EDWIN I. HATCH NUCLEAR PLANT UNIT NO. 1

AMENDMENT TO FACILITY OPERATING LICENSE

Amendment No. 59
License No. DPR-57

SAFETY EVALUATION BY THE OFFICE OF NUCLEAR REACTOR REGULATION
SUPPORTING AMENDMENT NO. 59 TO FACILITY OPERATING LICENSE NO. DPR-57

FIGURE 3.6-1

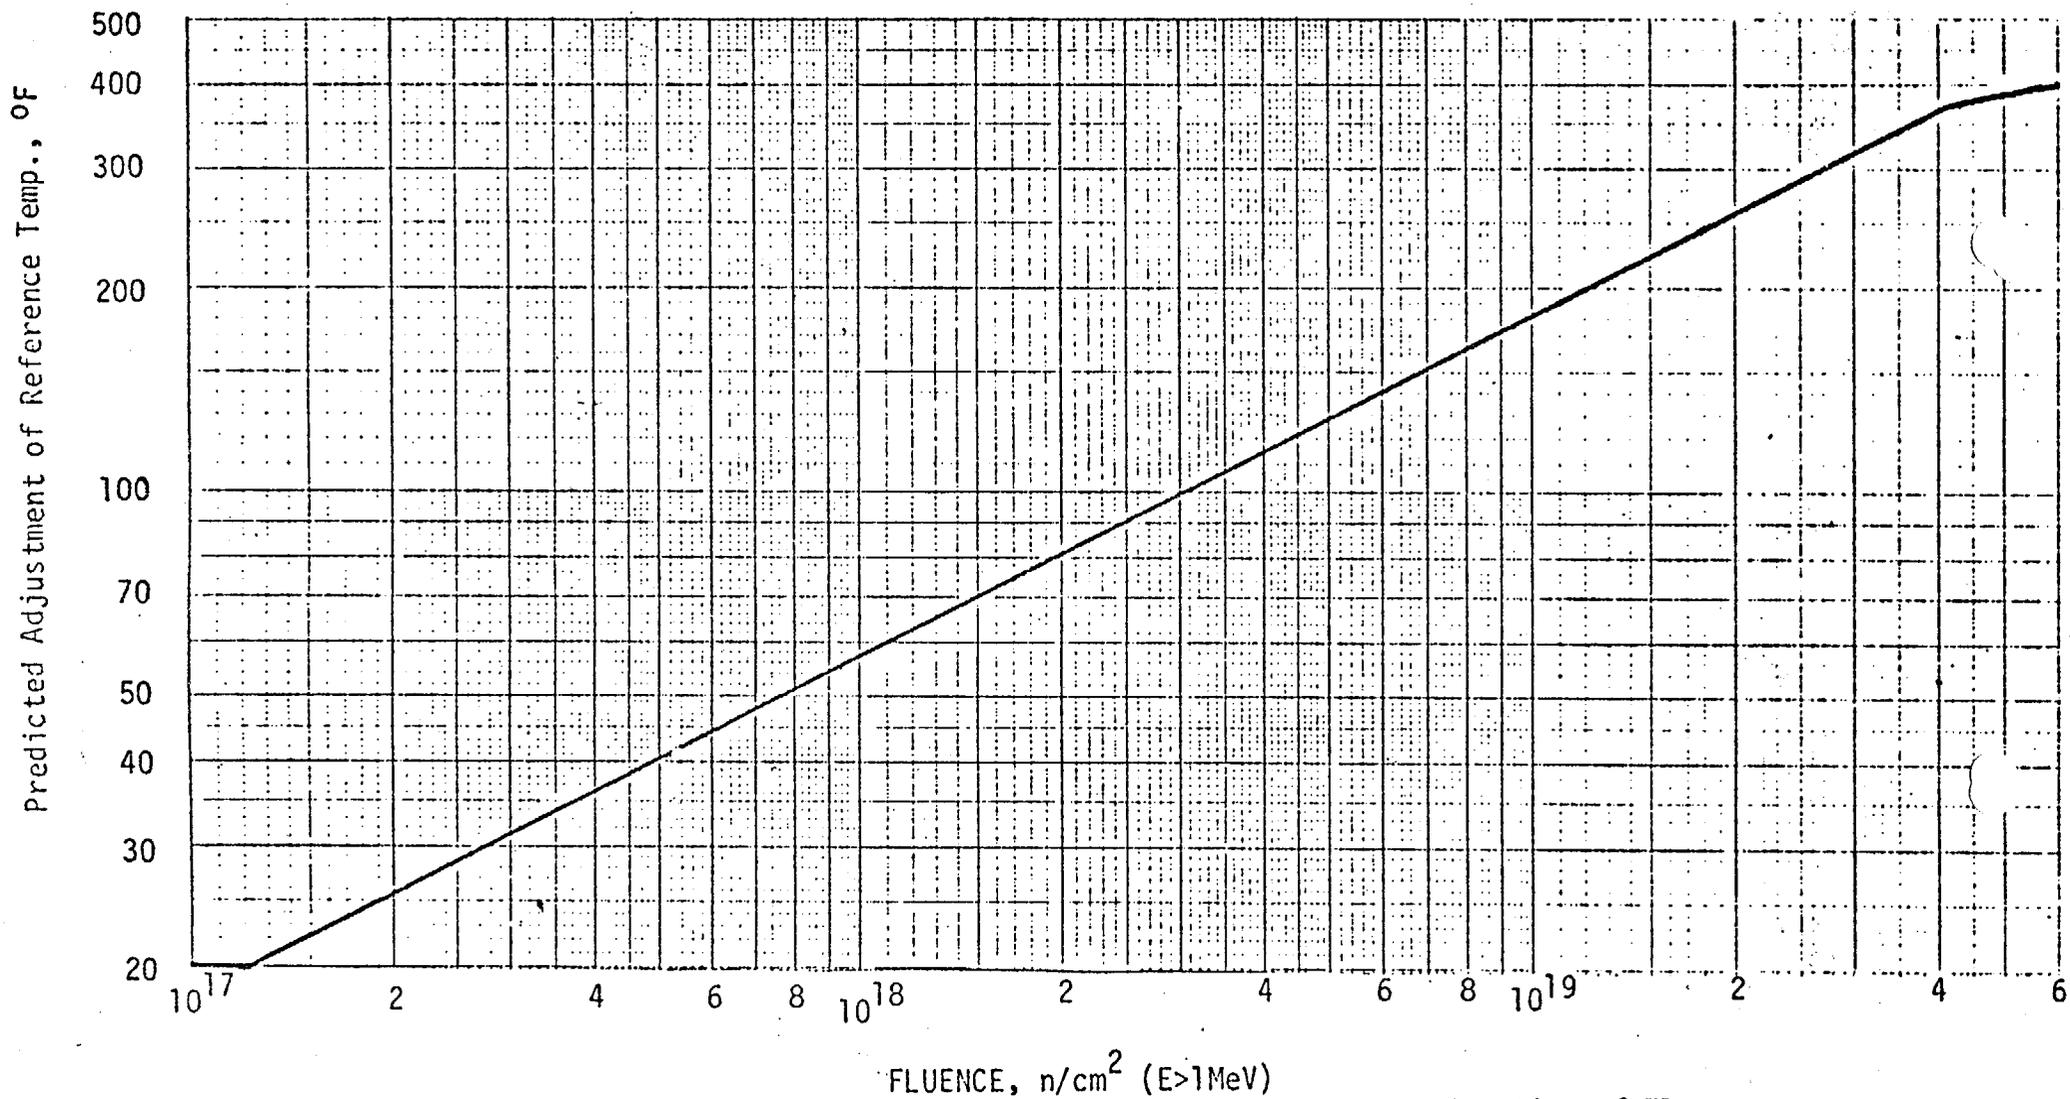
The Georgia Power Company submittal dated May 26, 1978 included pressure-temperature limits for hydrostatic testing, mechanical heatup and cooldown, minimum temperature for core operation (criticality), and damage estimate curves predicting the effect of neutron fluence on RT_{NDT} . These proposed operating limits include pressure-temperature operating curves based on an analysis of regions of discontinuities that are remote from the beltline region. The stress intensities used for this analysis were obtained by adjusting the results of the analysis made on the BWR/6 251 reactor vessel to account for differences between the design and material properties of these vessels. Since both vessels were designed to the same rule, i.e., Section III of the ASME Code, we find this procedure acceptable. Currently, the feedwater nozzle is the limiting region for the operating limits. This region will see very low radiation levels so that there will be no degradation of its materials; i.e., no increase in RT_{NDT} . On the other hand the materials in the beltline region are subjected to high radiation levels that will cause their RT_{NDT} values to increase. Because of this radiation damage, the beltline material will become the limiting material in about 4 EFPY. To account for this shift from feedwater nozzle to beltline region as the limiting material, the proposed operating limit curves, Figures 3.6.2, 3 and 4, provide curves based on both the nozzle region analysis and on the beltline region analysis. The pressure-temperature curves for the beltline region will be increased by the shift in reference temperature produced by irradiation as predicted in Figure 3.6.1. The estimated increases in reference temperature presented in Figure 3.6.1 were obtained from Regulatory Guide 1.99, Revision 1 using a copper content of 0.2%.

The relationship shown in Figure 3.6-1 is between neutron fluence and the predicted adjustment of reference temperature (RT_{NDT}). This relationship is based on NRC recommendations in Regulatory Guide 1.99, Revision 1 (April, 1977) and data contained in General Electric report NEDO-21708. In turn, this change in transition temperature can be related to a change in the temperature ordinate shown in Figure G 2110-1 in Appendix G of Section III of the Boiler Code.
